## General Response to the Review Comments

### Response to the review comments by Dr. Brian Barkdoll

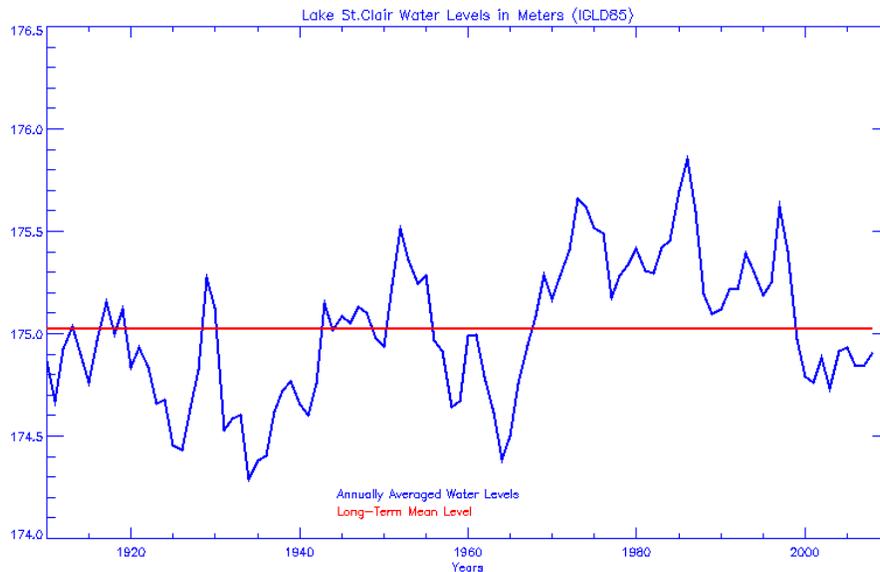
3) *Section 2.2 The mesh sensitivity results are not shown.*

The mesh independence study was based only on visual inspection of results and comparison with measurements. We have added a comparison figure to the report.
